YANKEE ATOMIC ELECTRIC COMPANY

Subject: TMI Action Plan Item II.B.1 - Reactor Coolant System Vents

II.B.1 REACTOR COOLANT SYSTEM VENTS

SKETCH A
 REACTOR COOLANT
 SYSTEM VENT SYSTEM

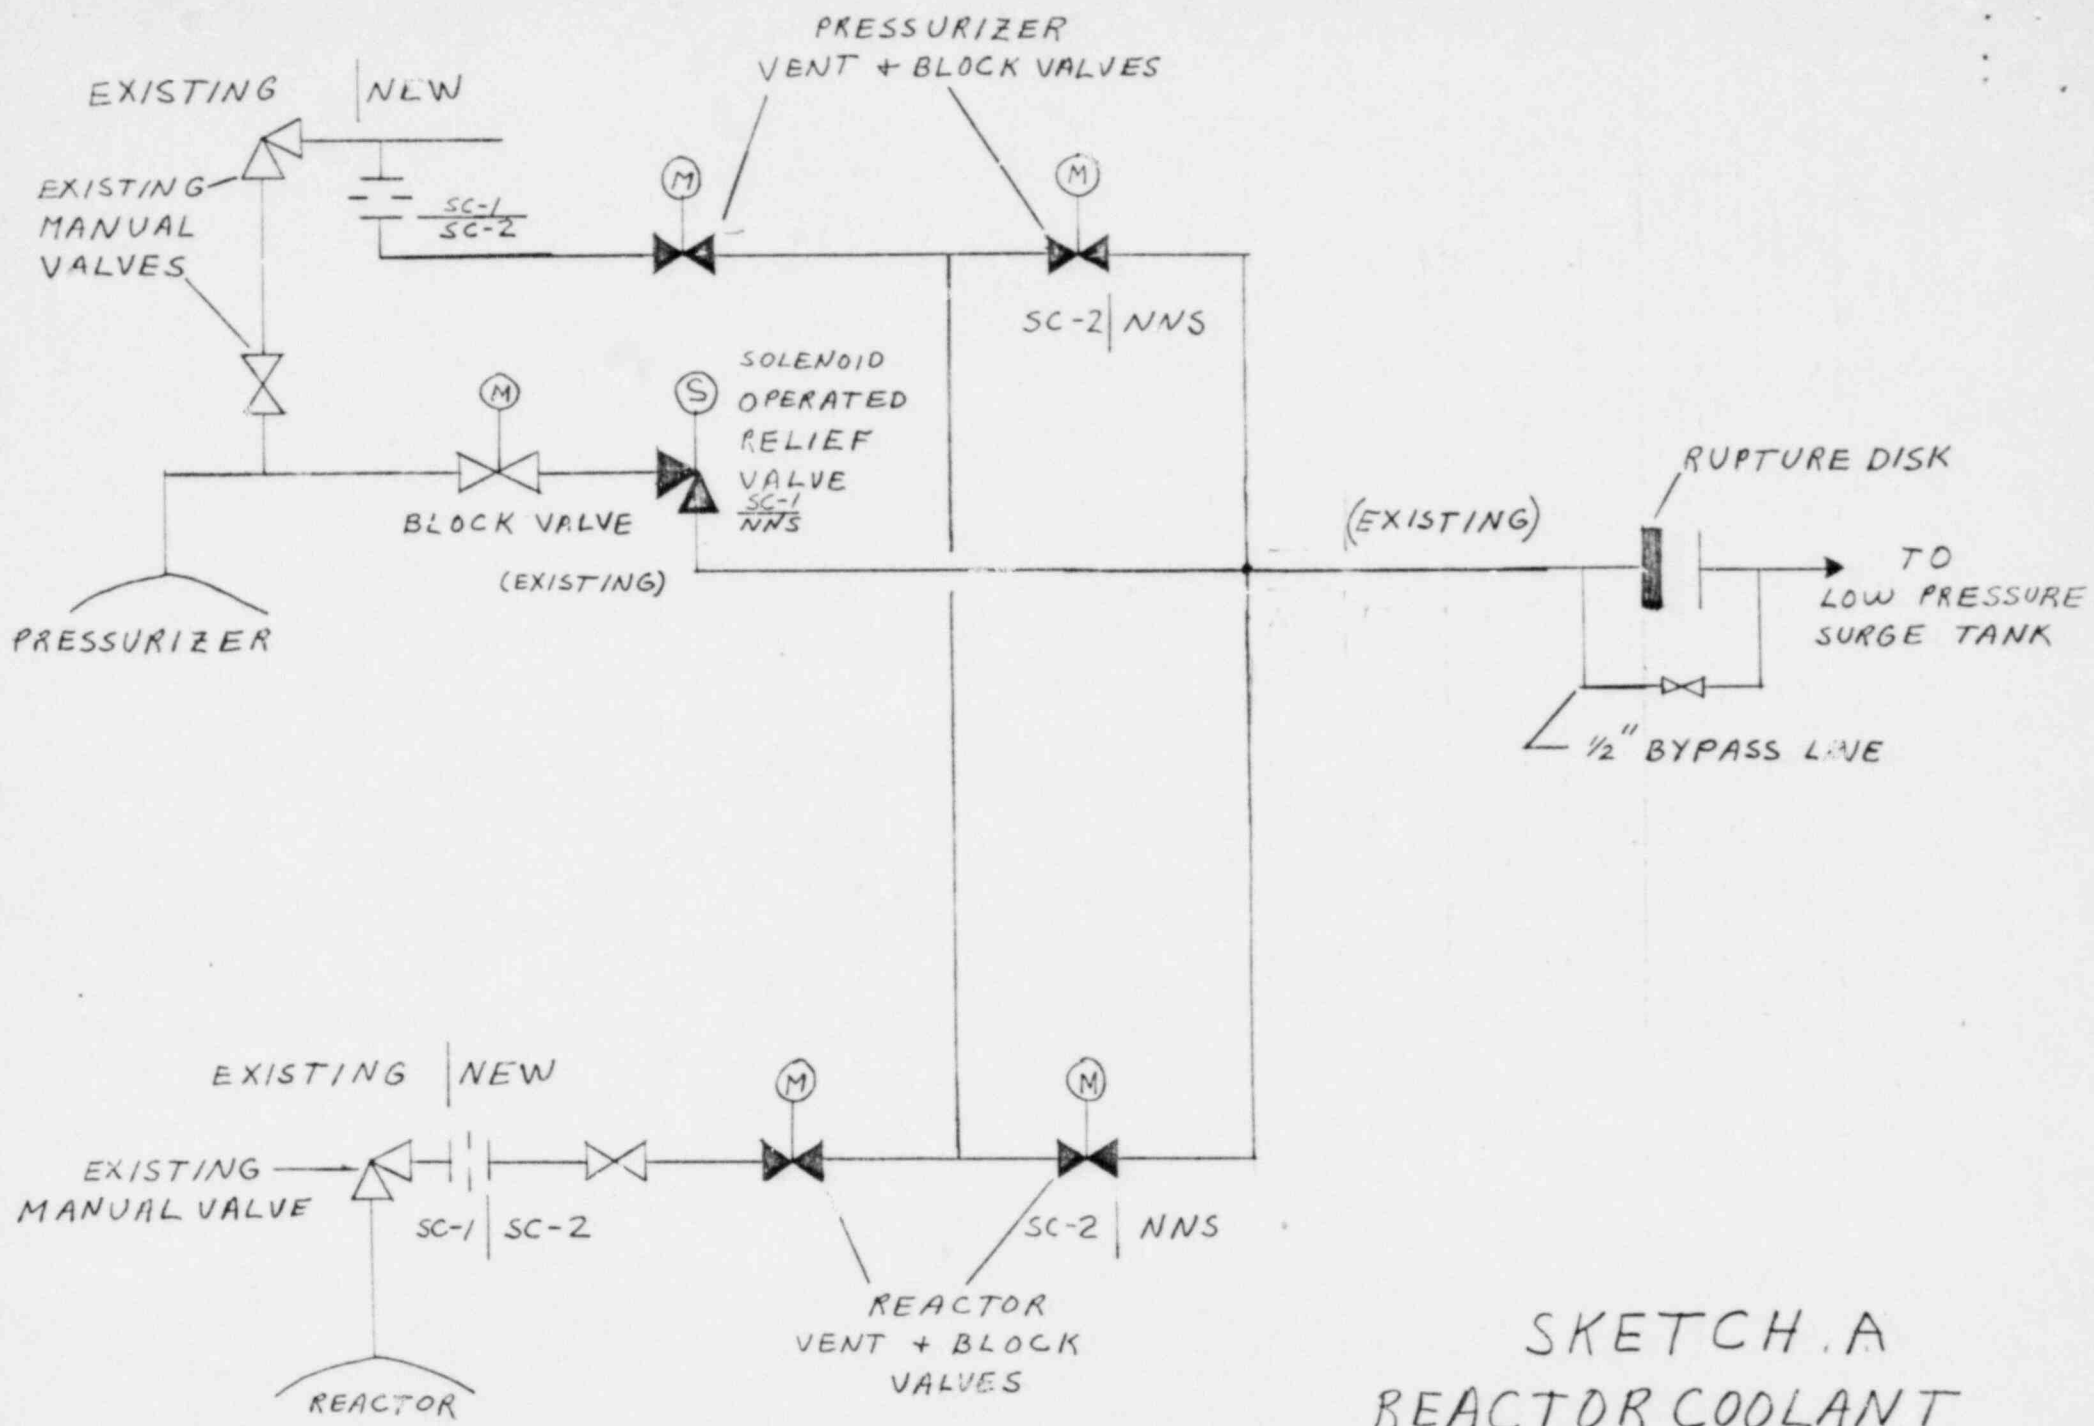
- (1) Submit a description of the design, location, size, and power supply for the vent system along with results of analyses for loss-of-coolant accidents initiated by a break in the vent pipe. The results of the analyses should demonstrate compliance with the acceptance criteria of 10 CFR 50.46.

- (3) The size of the reactor coolant vents is not a critical issue. The desired venting capability can be achieved with vents in a fairly broad spectrum of sizes. The criteria for sizing a vent can be developed in several ways. One approach, which may be considered, is to specify a volume of noncondensable gas to be vented and in a specific venting time. For containments particularly vulnerable to failure from large hydrogen releases over a short period of time, the necessity and desirability for contained venting outside the containment must be considered (e.g., into a decay gas collection and storage system).

- (4) Where practical, the reactor coolant system vents should be kept smaller than the size corresponding to the definition of LOCA (10 CFR 50, Appendix A). This will minimize the challenges to the emergency core cooling system (ECCS) since the inadvertent opening of a vent smaller than the LOCA definition would not require ECCS actuation, although it may result in leakage beyond Technical Specification limits. On PWRs, the use of new or existing lines, whose smallest orifice is larger than the LOCA definition, will require a valve in series with a vent valve that can be closed from the control room to terminate the LOCA that would result if an open vent valve could not be reclosed.

A flow diagram for the reactor coolant system vent system (RCSVS) is attached as Sketch A. The system adds the capability to vent the reactor vessel head or the pressurizer steam space.

Both vents tie into existing connections on the vessels. The reactor vent ties into the existing manual vent on the reactor head, while the pressurizer vent ties into the sample line on the power operated relief valve (PORV) connection to the pressurizer. Both vent lines are isolable from the vessels by existing manual valves.

Each of the new vent lines have been orificed at the connection to the existing lines. The orifice is sized so that a break in the vent pipe will result in a leak rate that is less than the makeup capacity of one charging pump. Therefore, a break in the vent pipe is not considered a loss-of-coolant accident and no new analyses are required to demonstrate compliance with the acceptance criteria of 10 CFR 50.46.

After the flow restricting orifice, each vent line contains two (2) motor operated valves (MOVs) in series, a vent valve and a block valve. Two valves in series are utilized to allow terminating the venting process in the event of a failure of one valve to close. The two vent paths are cross-connected after the first MOV. The reason for this will be covered below in the description of power supplies. The discharges of both vent valves are tied into the discharge piping of the PORV. This will allow for the collection of any leakage by the vent valves or any small discharges in the low pressure surge tank (LPST). Any large releases will be released to the containment atmosphere via the rupture disk in the line. (See Sketch A.)

The reactor vent valve and pressurizer block valve are powered from the same emergency motor control center (MCC). The reactor block valve is powered from the other emergency MCC. The pressurizer vent valve is powered from a nonemergency MCC, which is powered by the same emergency diesel that supplies the reactor block valve MCC in the event of a loss of off-site power. Therefore, in the event of a loss of off-site power, the vent and block valves in each vent path are powered from different emergency diesels. In case of a failure of one of these diesel power supplies, the RCSVS can still function with the two MOVs

powered from the remaining power supply utilizing the cross-connect piping.

The main criteria used for sizing the RCSVS was to insure that in the

event of an inadvertent actuation, the leak rate was within the capabilities of the normal makeup system. Therefore, an inadvertent actuation of the vent system would not constitute a LOCA.

Once this was accomplished, the vent rate for noncondensable gases was determined. Based on the volume of noncondensable gases generated from a 100% Zr - H₂O reaction, this system would vent these gases in less than one (1) hour.

The reactor and pressurizer vent lines have been orificed such that in the event of an inadvertent opening of the vent the resulting leak rate will be within the makeup capacity of one charging pump. An inadvertent opening of a vent will not constitute a LOCA as defined in 10 CFR 50, Appendix A, and will not result in ECCS actuation.

Each vent path contains a block valve to prevent a prolonged venting process due to a stuck open vent valve.
